TCEP Project No.: 850-013-16

ADDENDUM #1

DATE: September 8, 2016

TO CONTRACT DOCUMENTS ENTITLED: Biotech Connector
1901 N. 21st Street
Lincoln, Nebraska

A1.41A

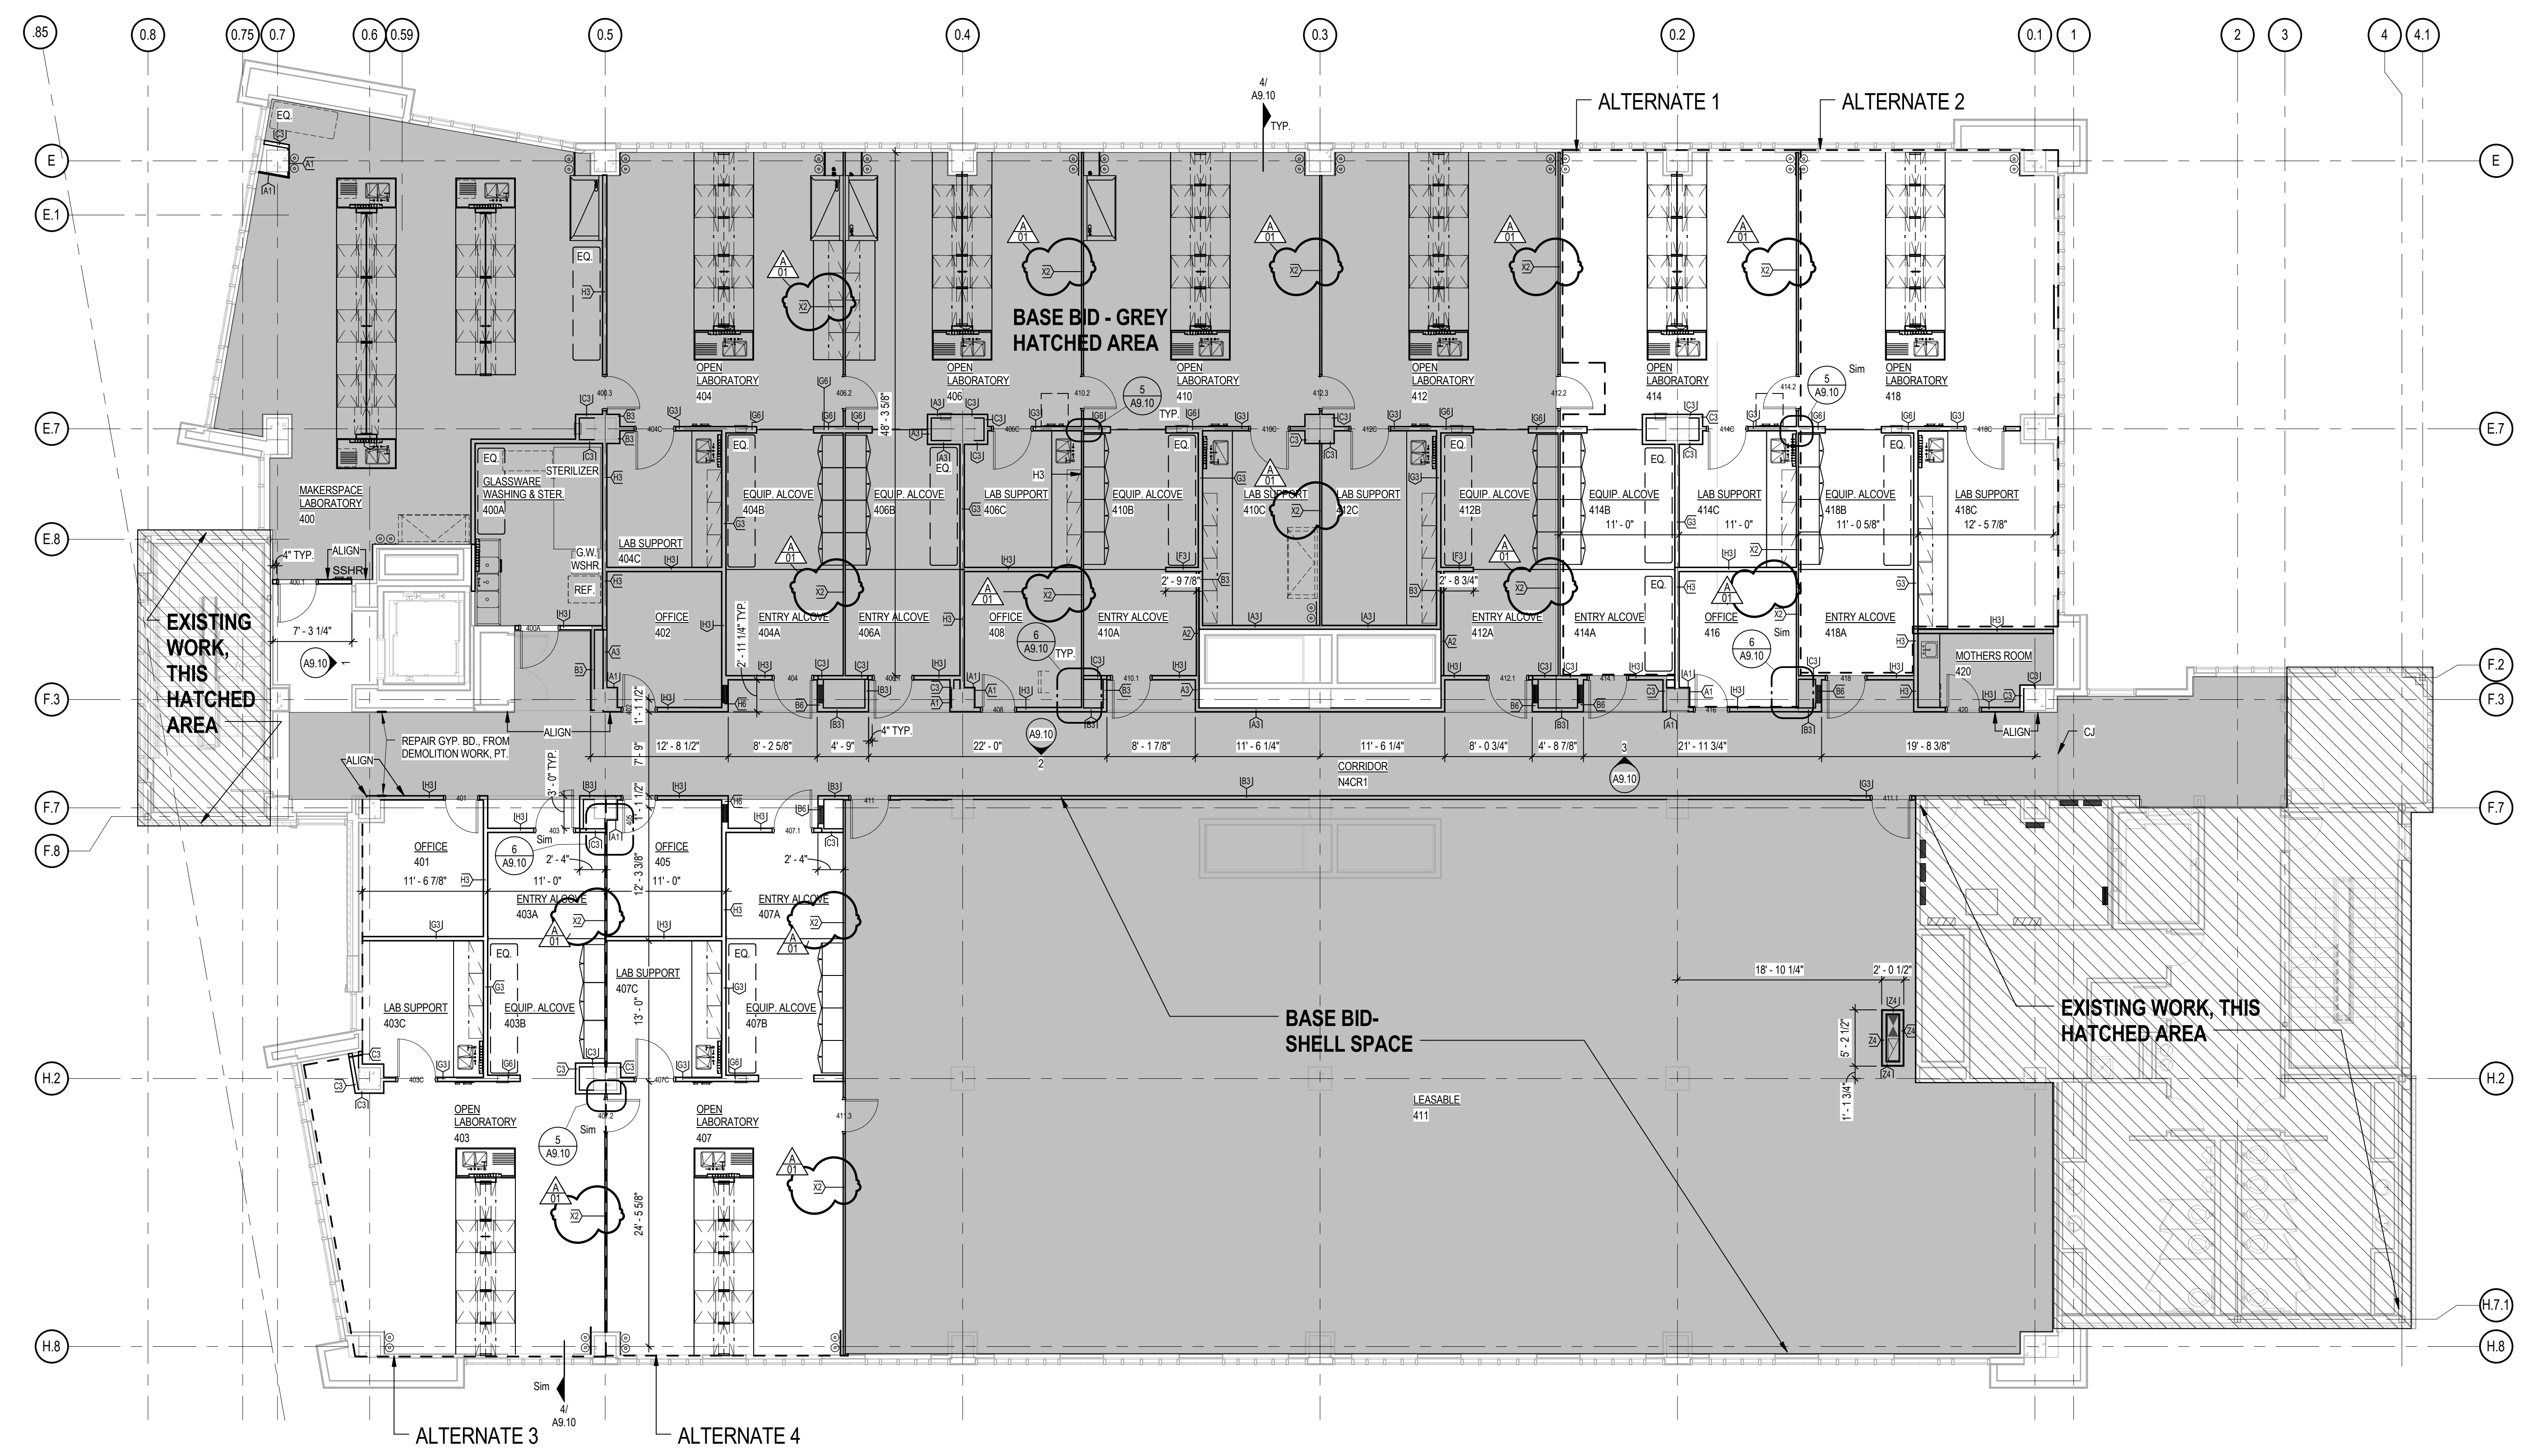
Item 1-4: Sheet A1.41A – Fourth Floor Plan – Alternate

See attached, revised, sheet for wall type clarifications. Wall type 'X2' shall be base bid wall type and wall type 'H3' shall be deduct alternate wall type.
